Comments to the Texas Commission on Environmental Quality Texas Pollutant Discharge Elimination System (TPDES) Permit No. WQ0015688001

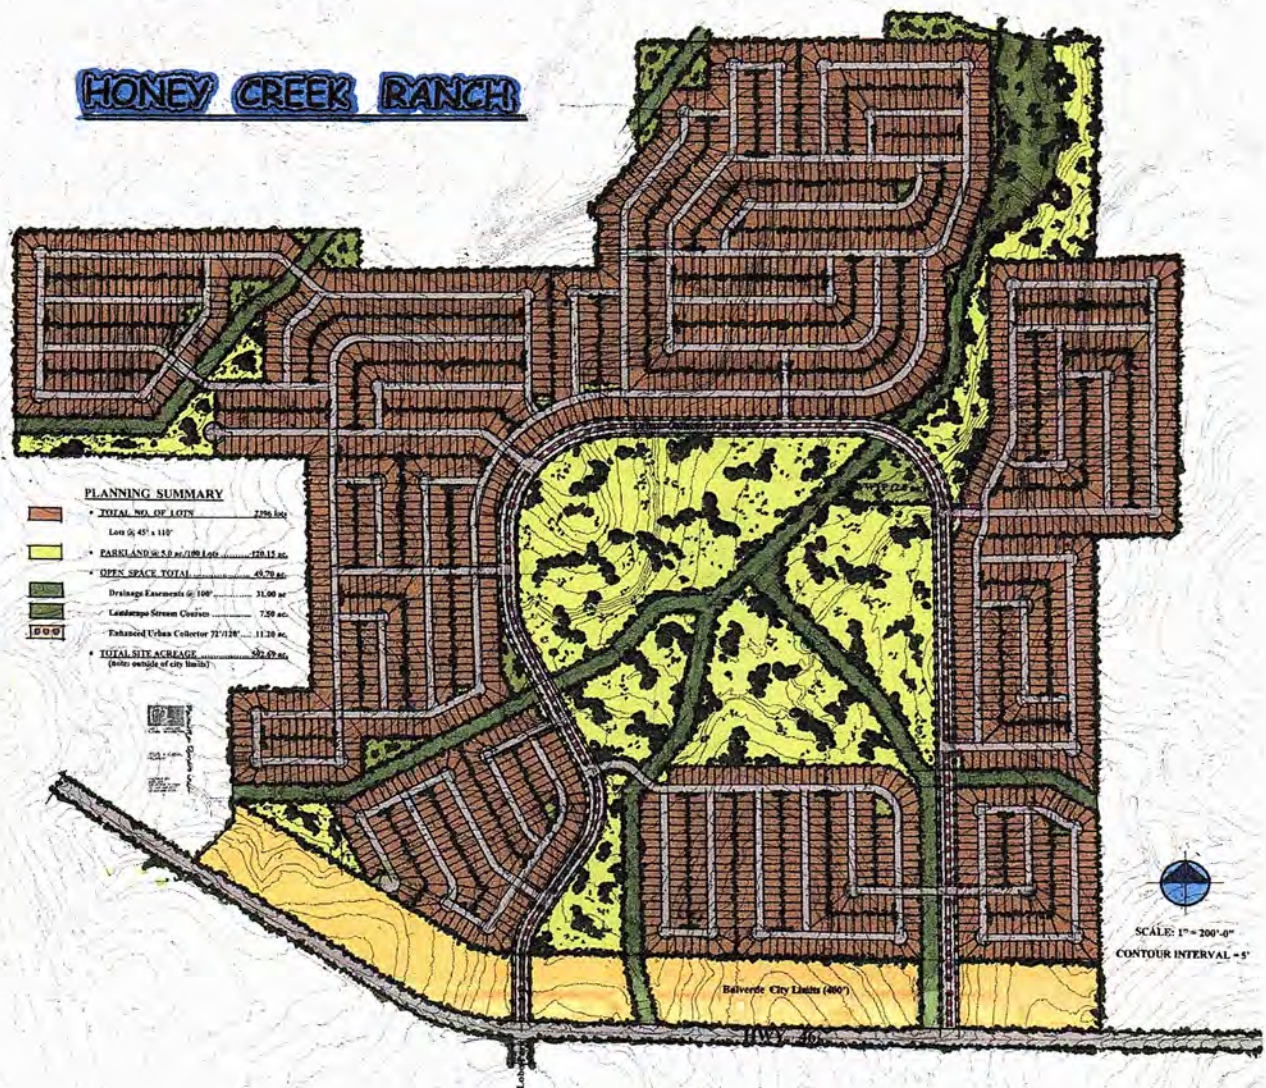
Regarding the idea that the proposed wastewater system would be implemented and run in a manner that would route the water resource to beneficial irrigation of “lawns and landscapes” rather than being discharged, the nature of the proposed land plan must be examined. What we see is a layout much more relevant to an area with gentle relief within an urbanized area, with densely-packed small lots laid over the area without much apparent consideration of the landforms, other than to provide for drainage easements. While the business aspects of this are indeed the business of Silesia Properties – it appears that the aim is to maximize lot yield without much regard to the character of the area – what we see does bear on how realistic it would be to accomplish much beneficial reuse.

Per the graphic showing the development plan – see above – it is proposed to place 2,396 lots on this land. The proposed design flow rate to be permitted is 500,000 gallons/day. The statutory design hydraulic application rate onto a subsurface drip field is 0.1 gallons/sq. ft./day, so this implies that there would need to be at least 5,000,000 sq. ft. of drip field area. (Note that if it were proposed to spray this water over the irrigated areas instead, the required area would be greater, and even then the instances of discharge would be “frequent” unless a large storage volume were to be provided, which would be rather costly.) That implies there would need to be an average irrigated area per lot of $5,000,000/2,396 = 2,087$ sq. ft. With the lots being only 45 feet wide, and presumably needing to accommodate about a 20-foot wide driveway, there would be precious little area in the front yards and parkways to provide this irrigated area, *way short* of the needed area.

So it is called to question where any beneficially irrigated area would be on this project. Other than drainage channels, which will not provide any area appropriate for this irrigation, there is no dedicated green space within the neighborhoods. The vast majority of the open space on this land plan is the large “central park”. The function of that area is entirely undefined, so the prospects for any irrigation within that area to be “beneficial” is entirely opaque at this point. Thus, the actual prospects for actually reusing, instead of discharging, the effluent remains entirely opaque. The assertion of the developer’s representative reported in The Rivard Report is entirely without any rational substantiation.

In any case, it is noted that the proposed 45-foot wide lots do not conform with the City of Bulverde subdivision ordinance. Which highlights that the land plan will have to be revisited in any case, since this development must be run through the City’s subdivision process. It is called to question whether it is relevant and proper for TCEQ to consider a permit application that is predicated on a development plan that is so obviously unrealistic. This is another aspect of TCEQ’s process that must be called to question. Its actions *should support, rather than degrade*, such intertwining societal processes.
